Ruhe Subdivision

Minor Plan 2013-201

Memorandum

SUBJECT: Ruhe Subdivision
Minor Plan 2013-201
PRELIMINARY/FINAL PLAN REVIEW

EXISTING FEATURES (EXPANDED VIEW, 50 SCALE)
RUHE MINOR SUBDIVISION PRELIMINARY/FINAL PLAN
 2442 HUCKLEBERRY ROAD
 SOUTH WHITEHALL TOWNSHIP
 LEHIGH COUNTY, PENNSYLVANIA

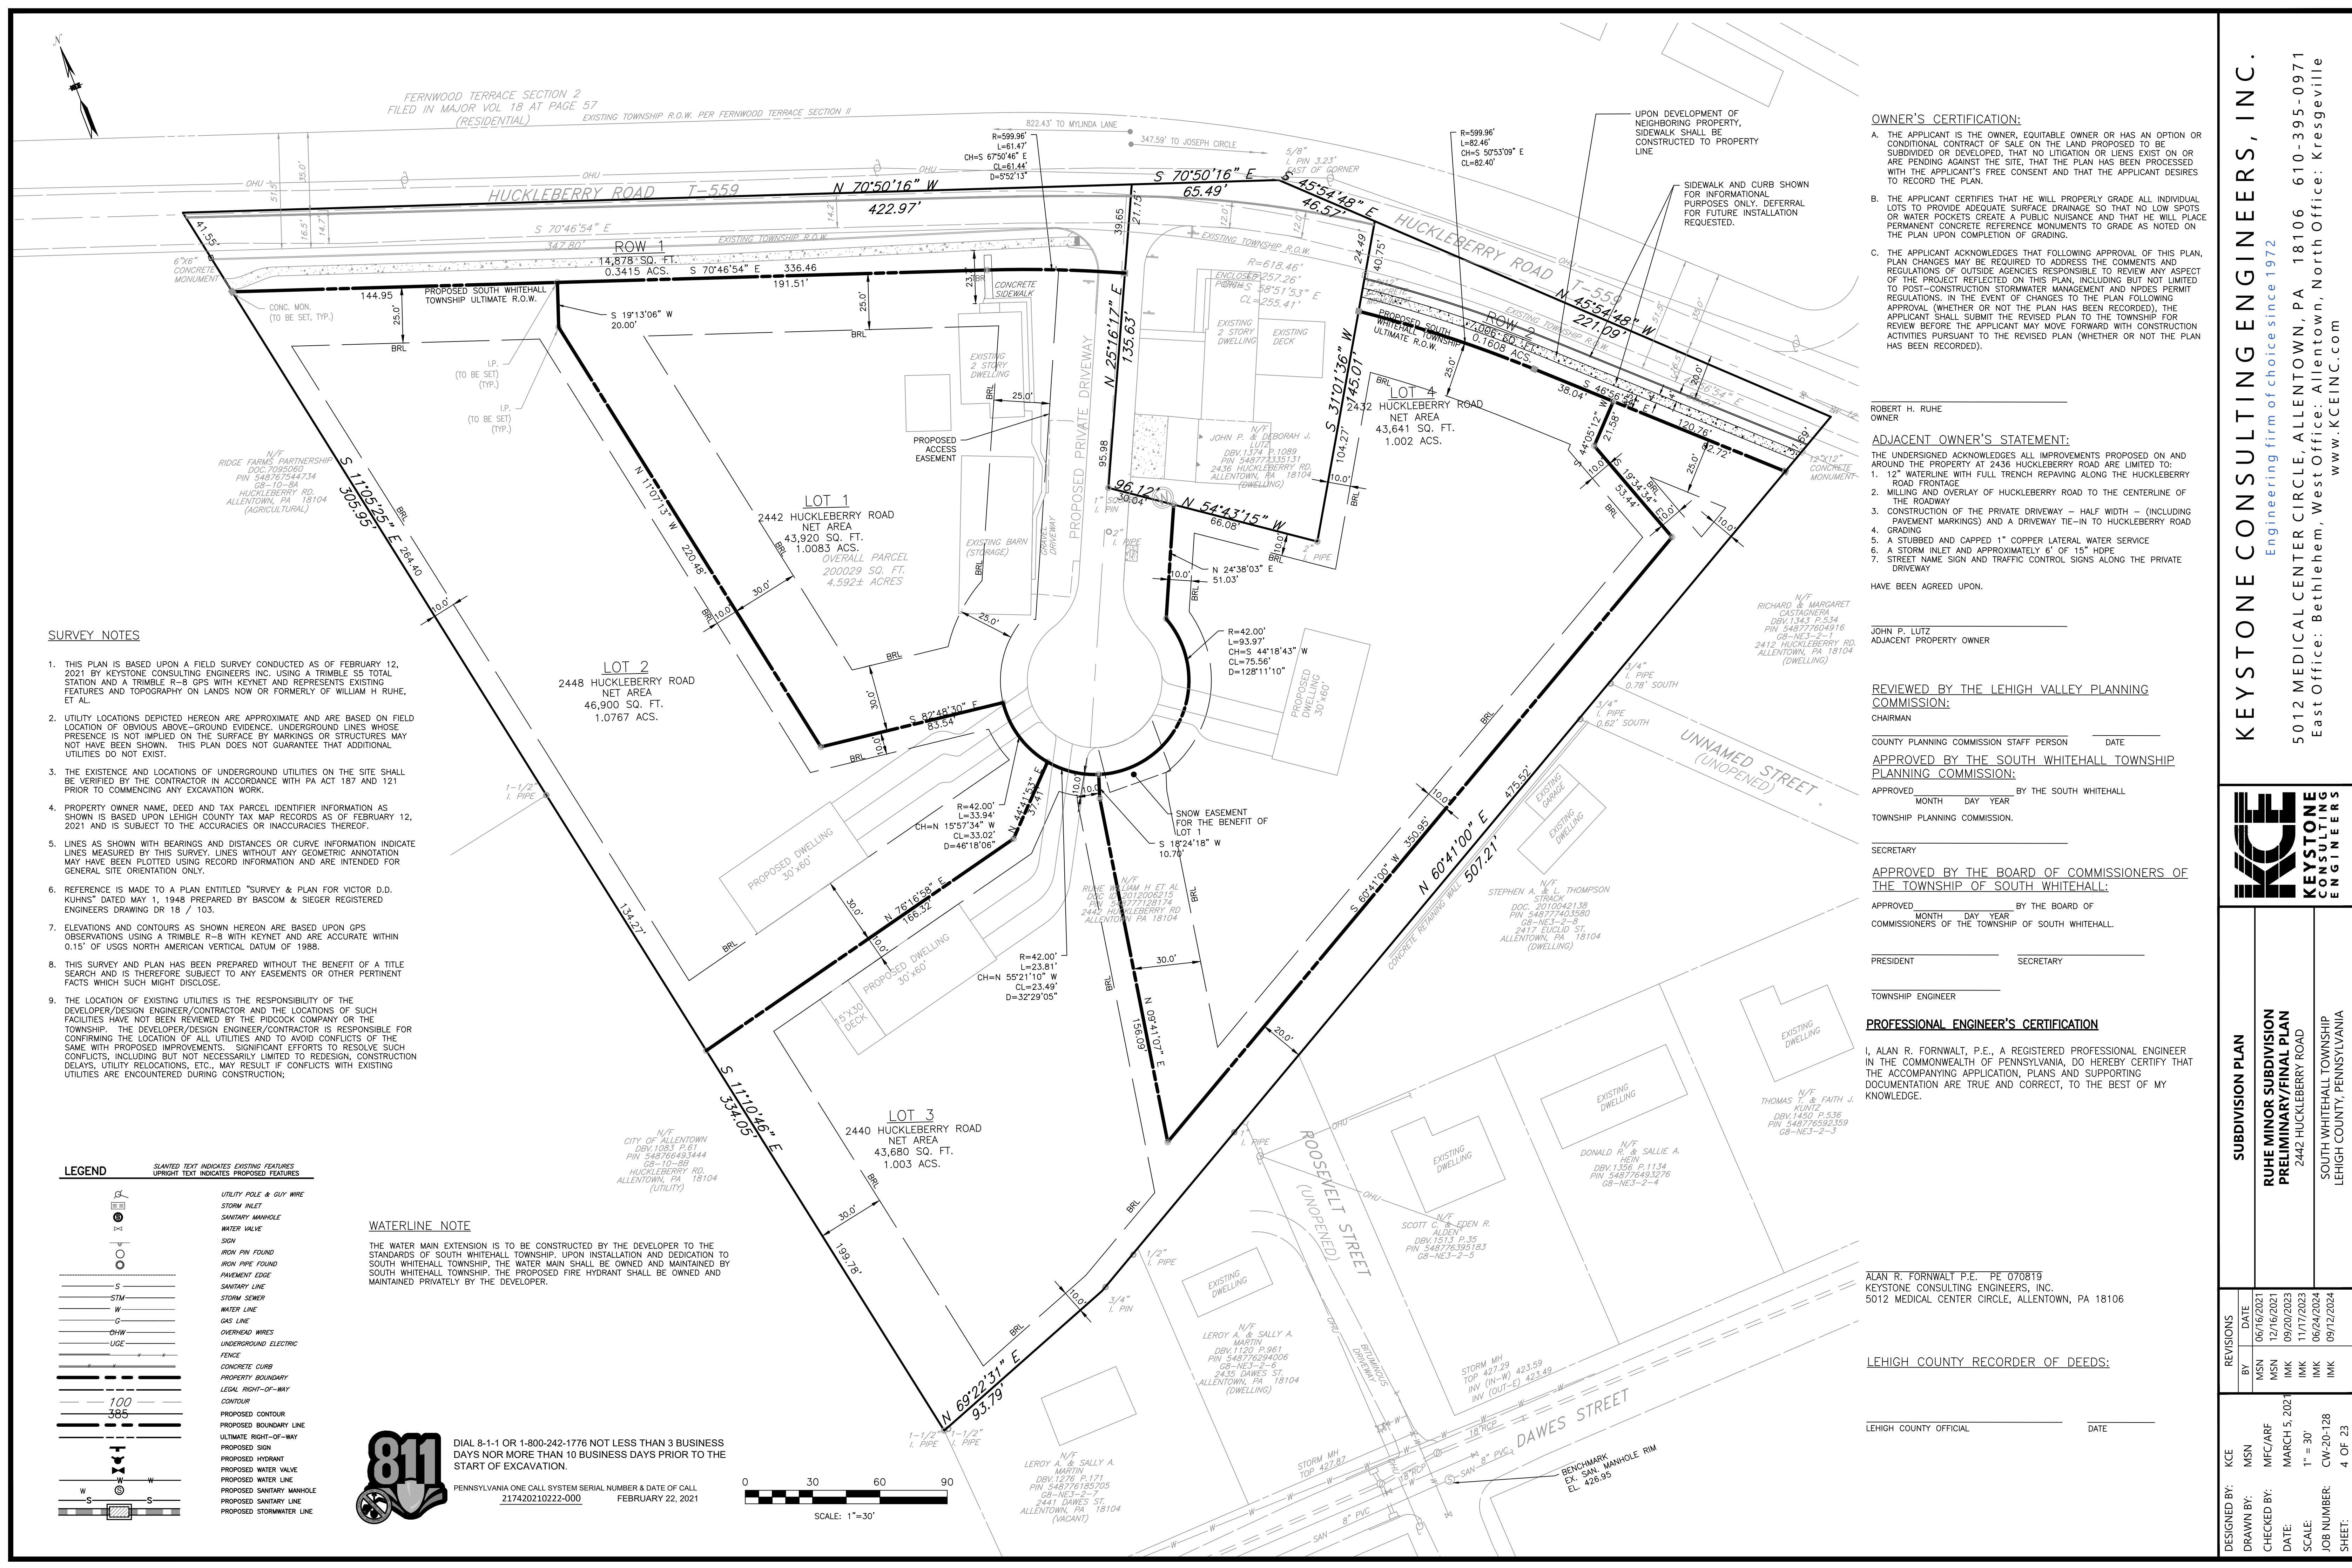
6. We note the following survey related comments:
 - a. Check the scale of the Existing Features (Expanded View, 60 Scale) Plan (Sheet 3). The plan does not appear to be drawn to scale;
Response: The scale has been revised accordingly.
 - b. Check the scale of the Stormwater Easement – Exhibit 'D' as the graphic and written scales are not consistent;
Response: The scale has been revised accordingly.
 - c. Sign and seal each legal description;
Response: Signature and seals will be provided under separate cover with any easement agreements.
 - d. Update the bearings and distances to be consistent between the Legal Descriptions and associated Exhibits (e.g., Ruhe Access Easement, Lutz Property Access Easement, etc.);

GRADING & DRAINAGE PLAN
RUHE MINOR SUBDIVISION
PRELIMINARY/FINAL PLAN
2442 HUCKLEBERRY ROAD
SOUTH WHITEHALL TOWNSHIP
LEHIGH COUNTY, PENNSYLVANIA

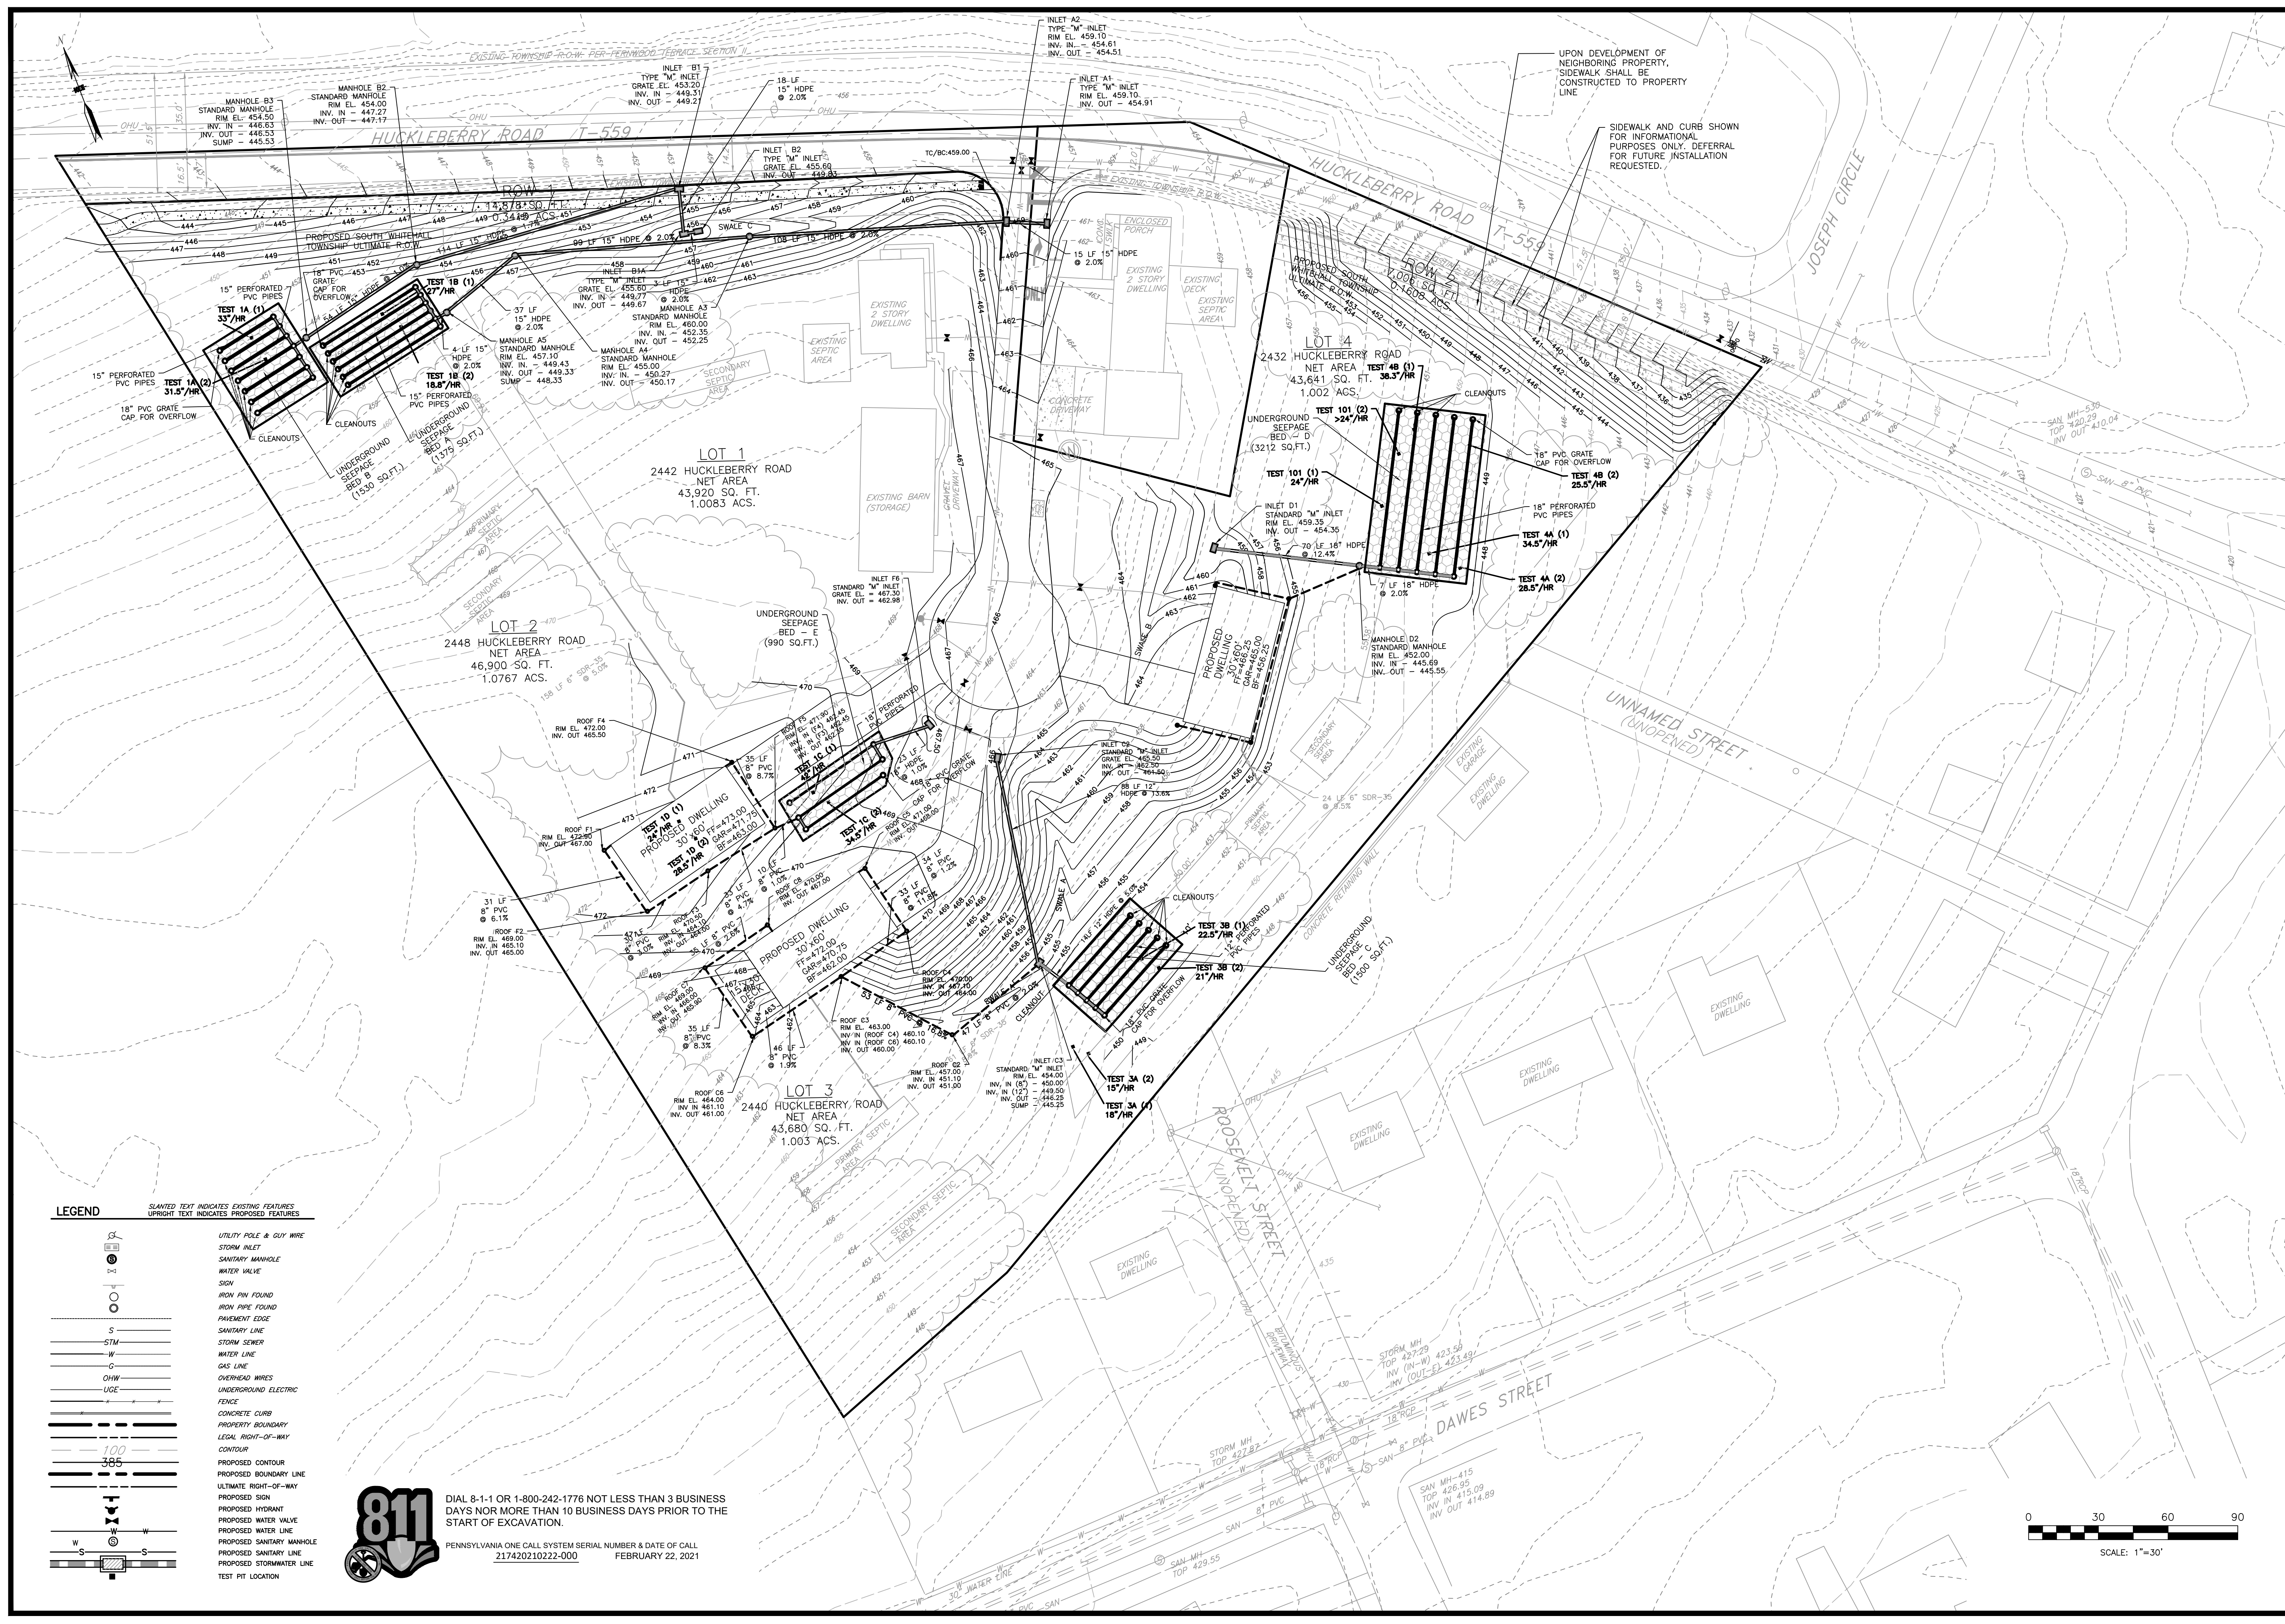
4. Grading is shown on the adjacent property to the west. In addition to the "Match Sidewalk and Grading" Note (Sheet 9) obtain and show necessary construction easements. We note that the design will lower the edge of the road approximately 2.5 feet and should be designed in a manner that will not rely on construction of the adjoining development.
Response: A 15'x20' temporary construction easement is now shown on the adjacent property to allow for grading and full construction of the sidewalk.

UTILITY PLAN
RUHE MINOR SUBDIVISION
PRELIMINARY/FINAL PLAN
2442 HUCKLEBERRY ROAD
SOUTH WHITEHALL TOWNSHIP
LEHIGH COUNTY, PENNSYLVANIA

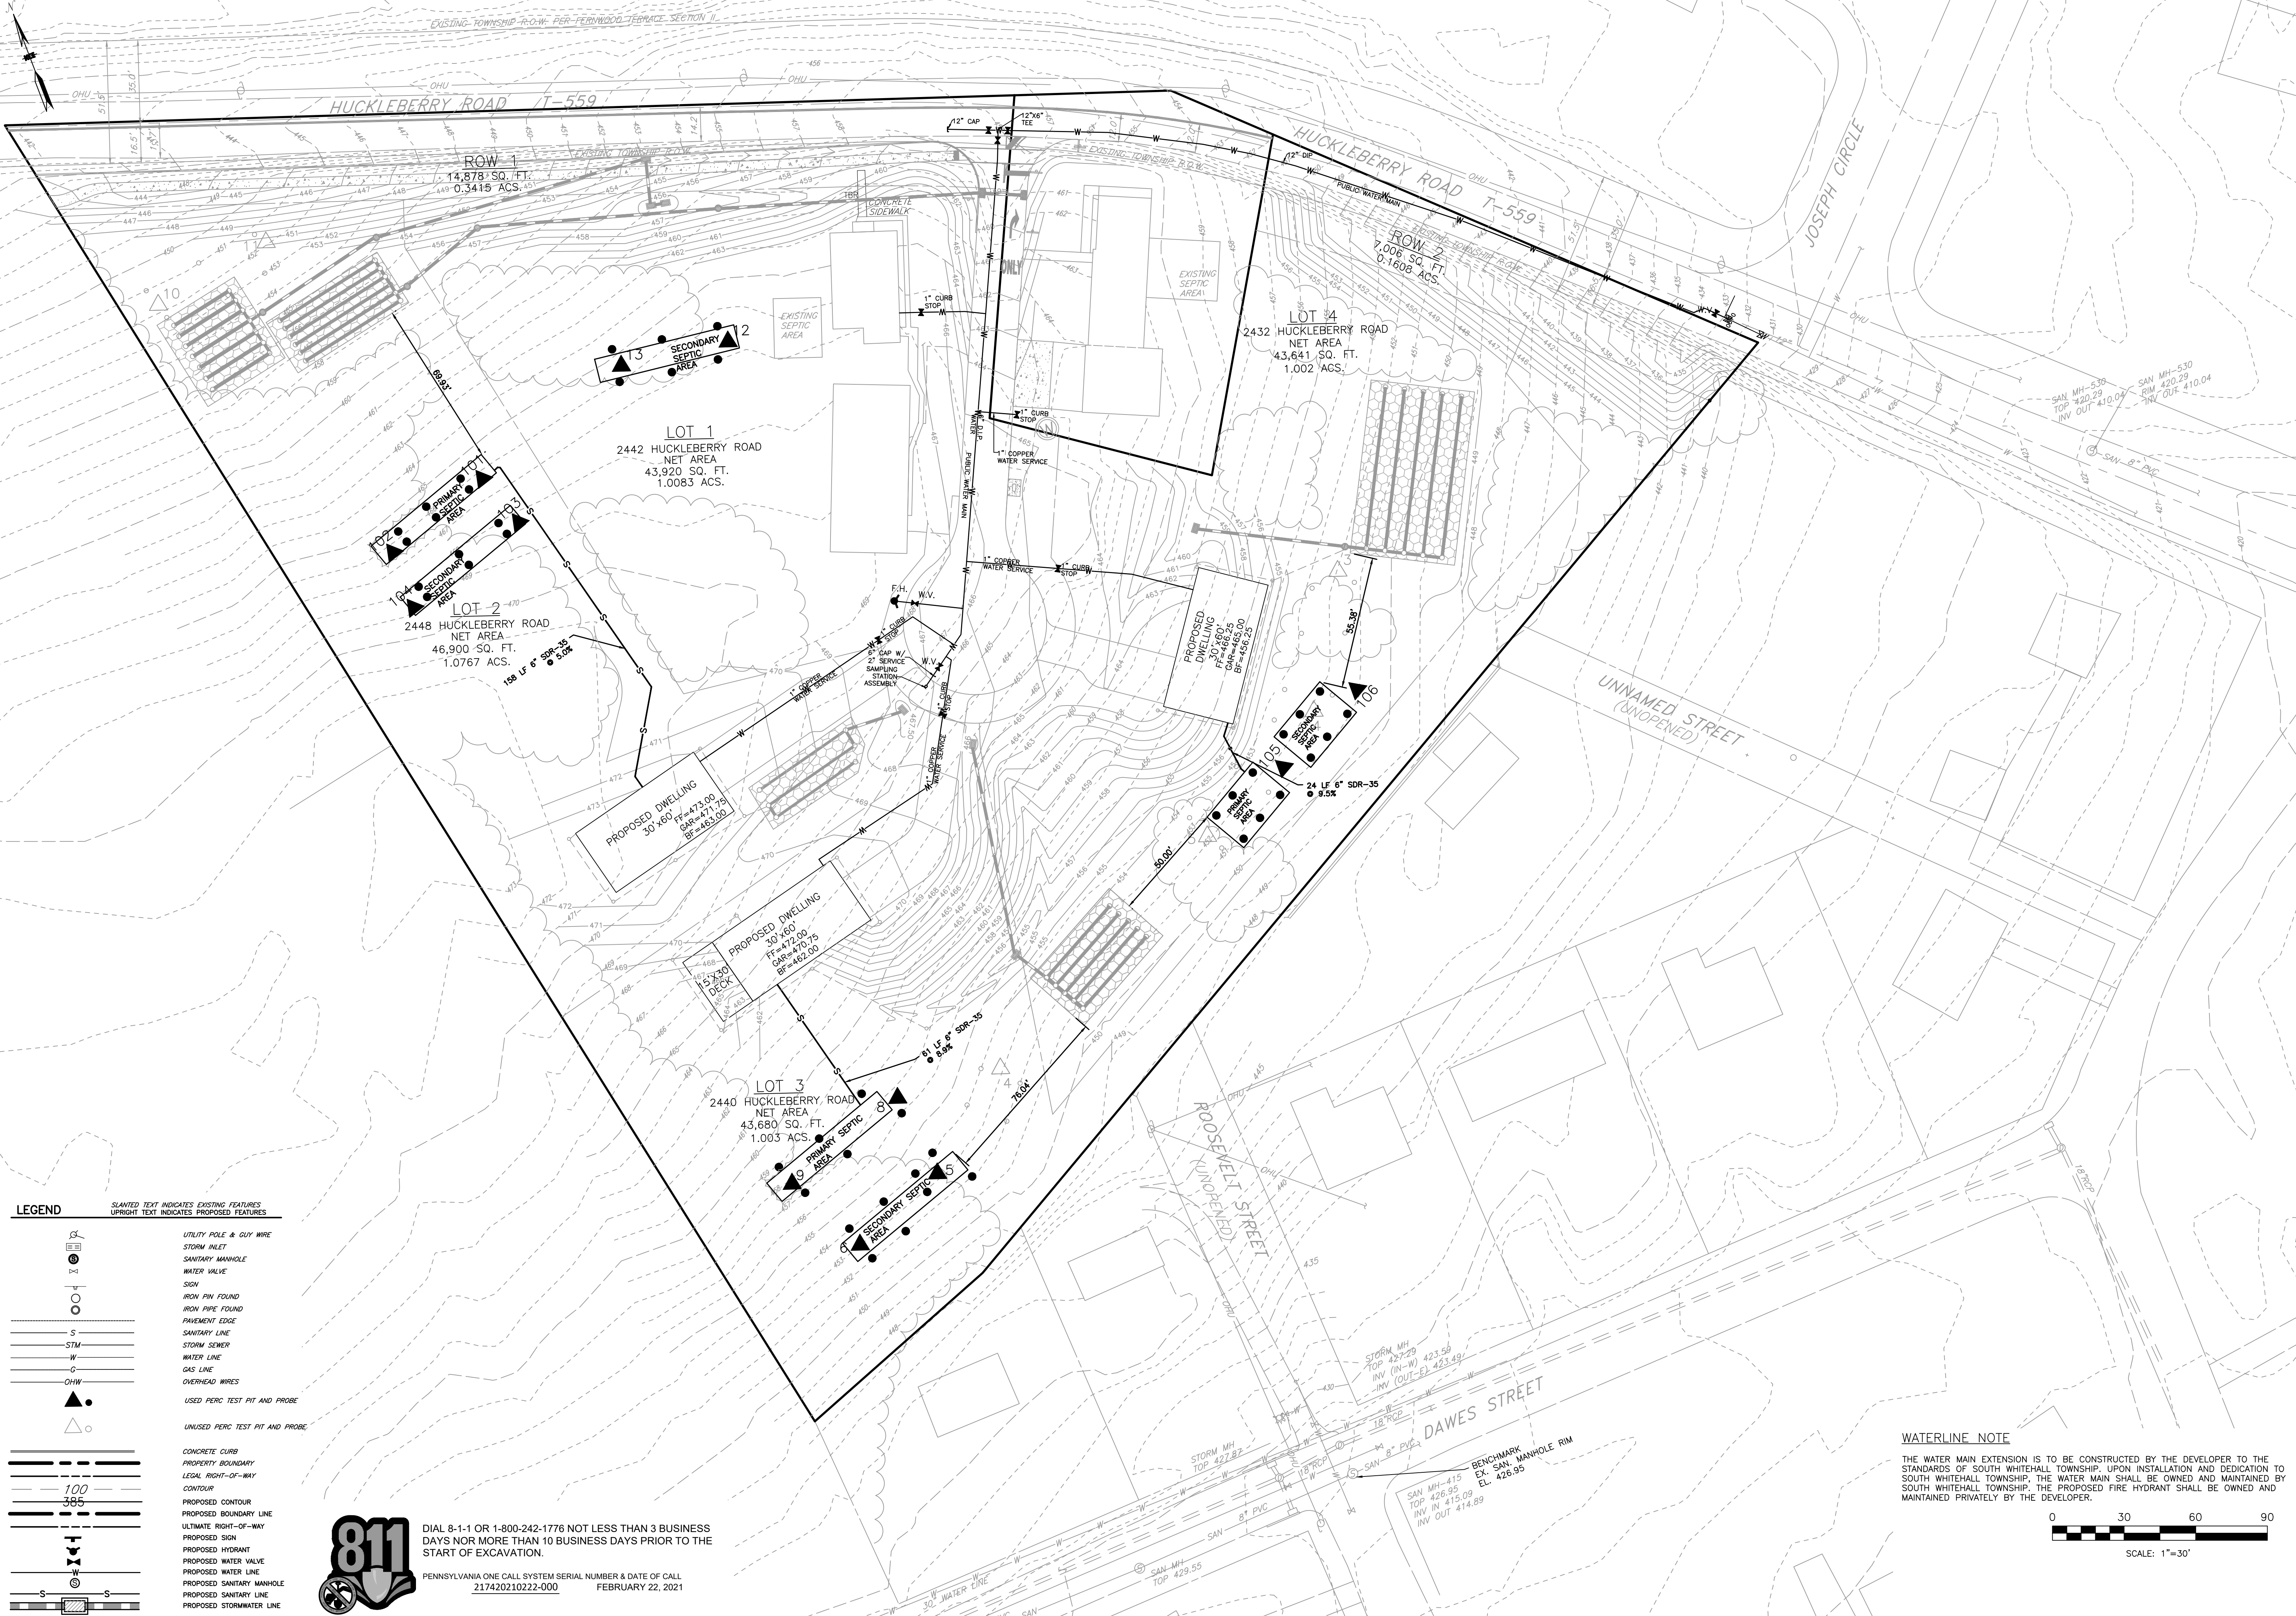
1. **Utility Plan: Sheet 10 of 23:**
